Febeliec answer to the Elia public consultation on the scenarios, sensitivities and data for the CRM parameter calculation for the Y-4 Auction for Delivery Period 2025-2026

Figure 1: Belgian electricity demand 2000-2019 (source: Elia, received 27/05/2020)

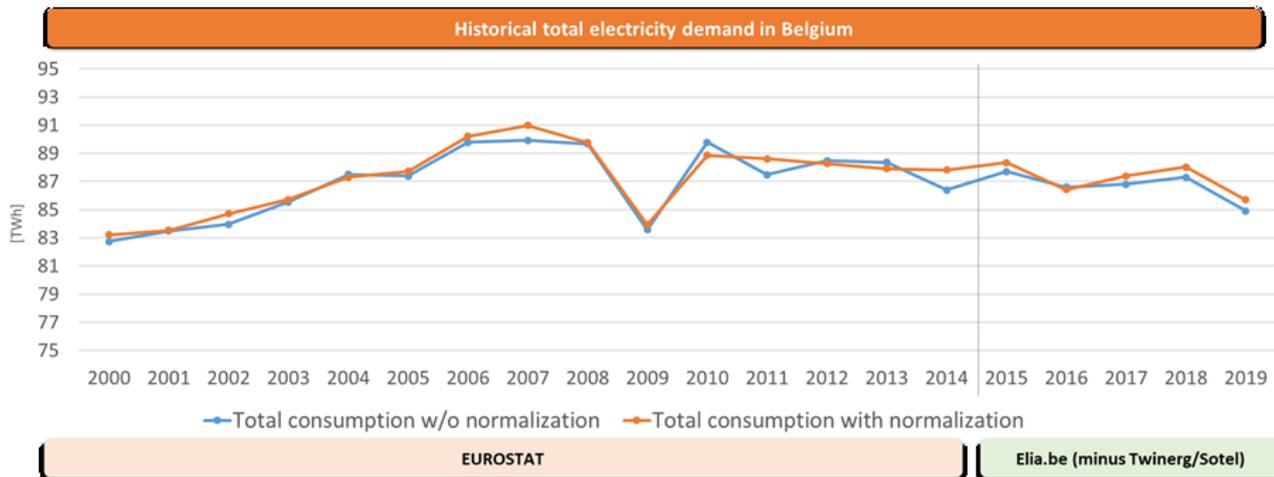
As can be seen from this data, the 2008 financial crisis, which was the major economic crisis in the current millennium with substantial global economic impact, shows a clear drop of more than 6TWh (or around 7% of Belgian consumption) in the wake of this crisis. A decade later, Belgian electricity demand has still not regained pre-2008 levels (with a.o. 2019 showing even a continued decrease in overall demand, reaching a level that was last seen in 2002, despite a substantial increase in Belgian GDP over that period). While the underlying reasons for this observation are beyond the scope of this consultation (e.g. impact of energy-intensity of GDP-growth, impact of energy-efficiency measures, ...), the trend can be clearly observed. Important in the light of the current covid-19 crisis, which will presumably have a much more pronounced effect on the global economy, is that it would be imprudent to not take into account such impact on Belgian electricity demand, also when looking at 2025 and beyond. Febeliec asks that at the very least additional sensitivities are included (see below) in case this impact would not be considered in the central reference scenario, and this in particular to avoid that the analysis would indicate a potential need for a CRM, based on outdated data sets, leading to a very costly¹ yet unnecessary subsidy scheme to be financed by consumers.

(with very little fundamental differences between normalised and non-normalised data, other than that in the data set normalised data on average slightly overestimates real electricity demand), electricity demand dropped very sharply in the aftermath of the 2008 financial crisis (minus 6 TWh or around 7%), which showed a less pronounced reduction in economic activity than can now already be observed by the non-ended covid-19 crisis, with a recovery afterwards that still has not reached in 2019 the pre-2008 level (still more than 3,5 TWh down compared to 2008 levels). Febeliec would thus propose to add two times two new sensitivities. A first additional sensitivity set could be to take the impact of the 2008 financial crisis as a proxy (so a drop of 6TWh in overall Belgian electricity demand based on the provided demand data from Elia) and then have two variations on this, one with a V-shaped recovery (as after the financial crisis of 2008, yet also there with even a decade later still electricity demand levels that are several percent lower) and one with a much slower recovery (to mimic a second wave of covid-19 or other effects that could generate additional damage to the economic tissue, with increased ripple-through effects in 2025 and beyond). A second sensitivity set would then contain two similar sensitivities, but based on a much more pronounced drop in electricity demand in 2020 (e.g. -10 TWh). Febeliec proposes these four additional sensitivities as the current proposed sensitivity based on the NECP of end 2019 does not take into account any scenario with a decrease in electricity demand, a scenario that in any case should be analysed unless one would to consider the covid-19 crisis as irrelevant.
